June 2, 2015

**RE: Paseo del Norte Sports Complex, Tract A, Loop Industrial Park
Grading and Drainage Plan
Engineer's Stamp Date 5-20-2015 (File: C17-D008)**

Re: Paseo Del Norte Sportsplex, Hydrology Re-Submittal

date
5-20-15
sheet
c002

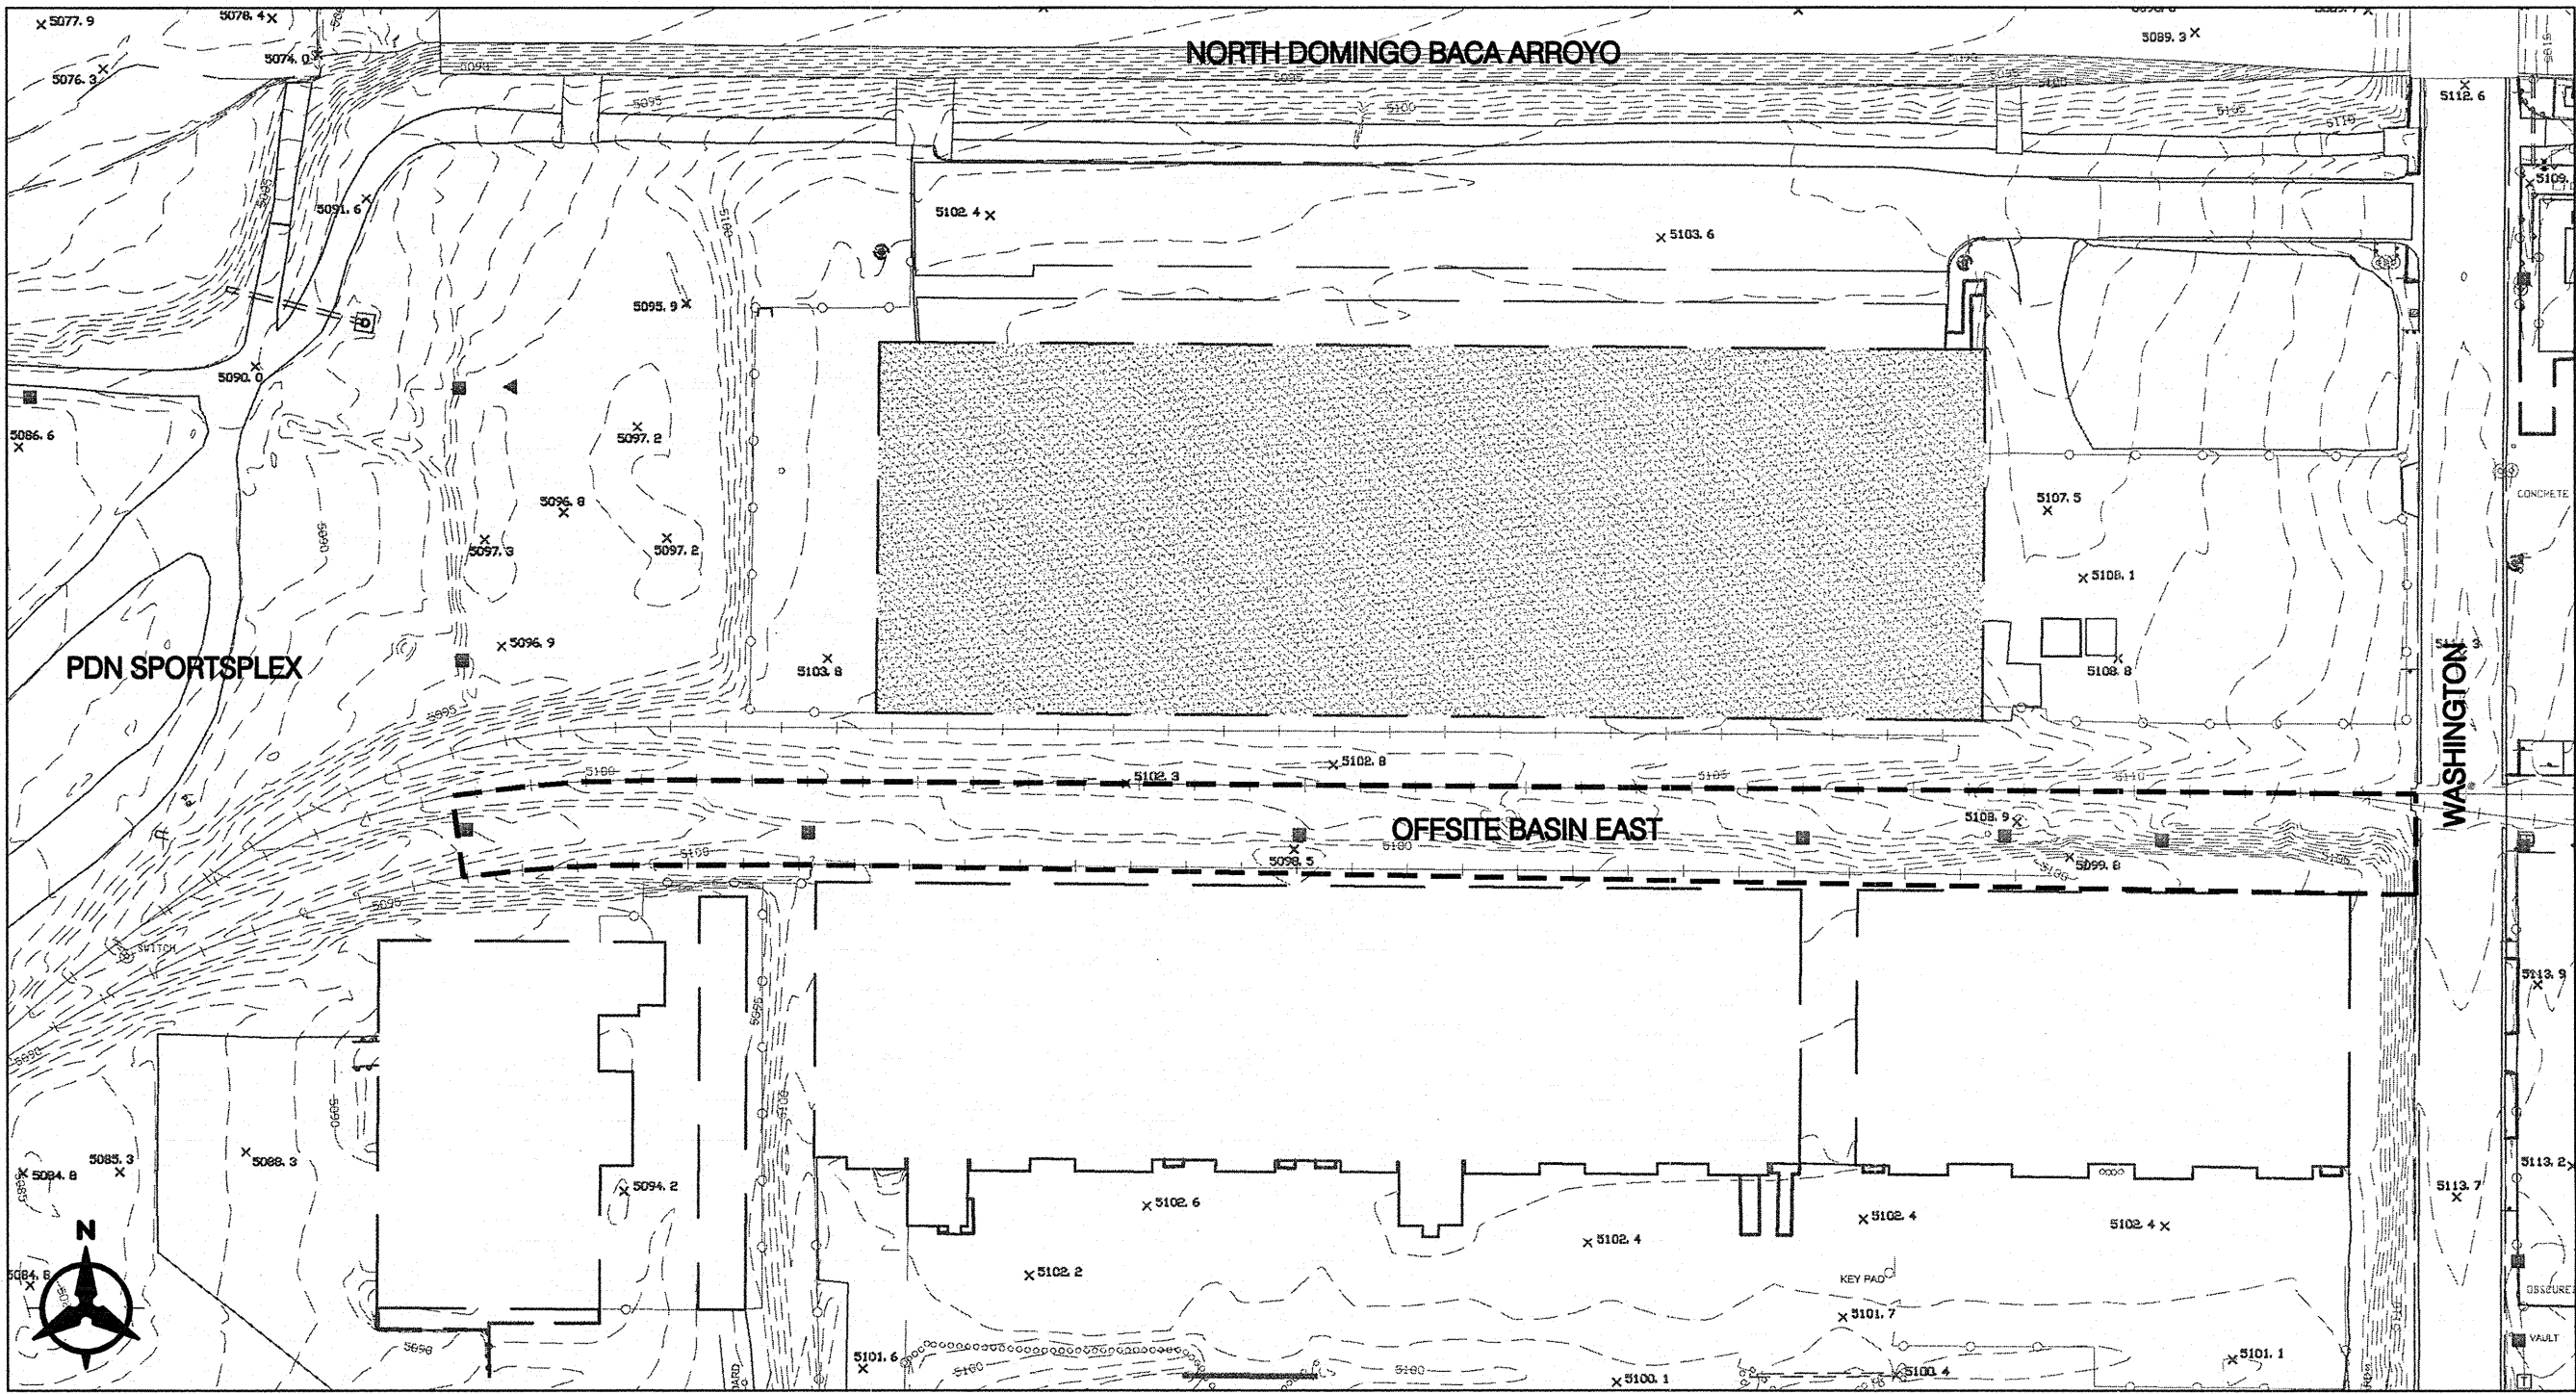
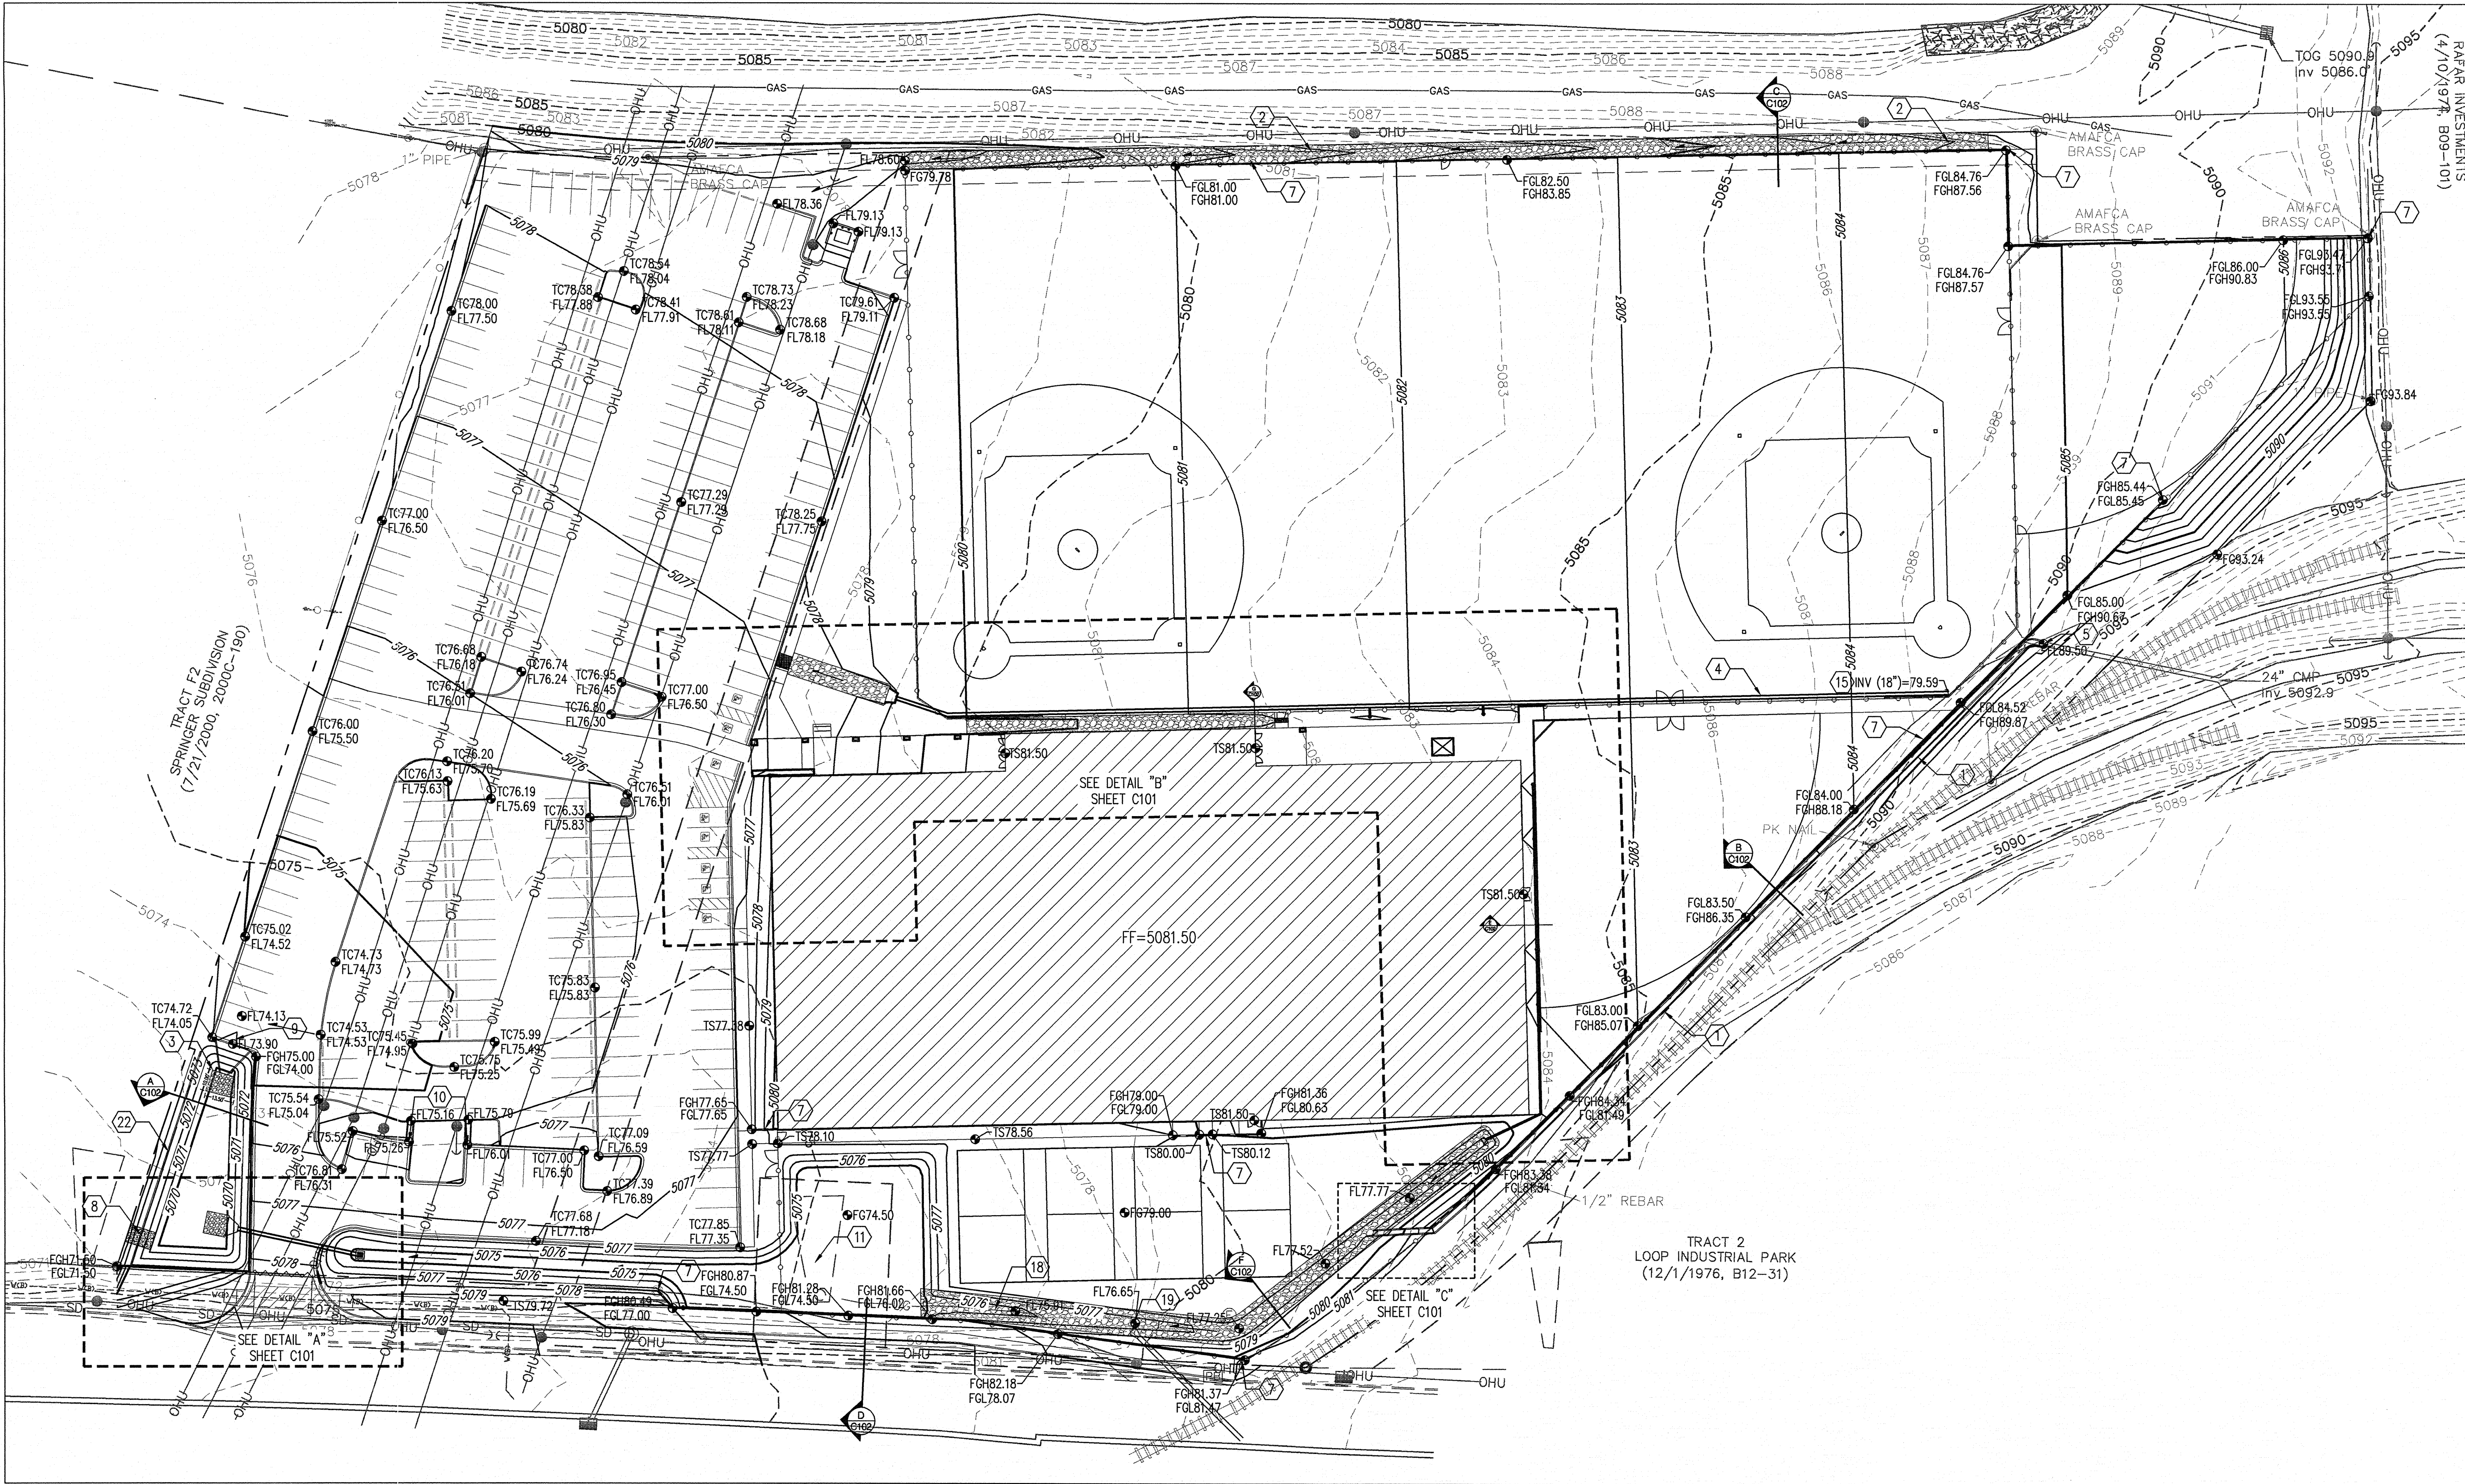
- 4) For SD-1, SD-2, and SD-3 on Sheet C002, the actual flow is shown to exceed capacity. Revise as necessary.
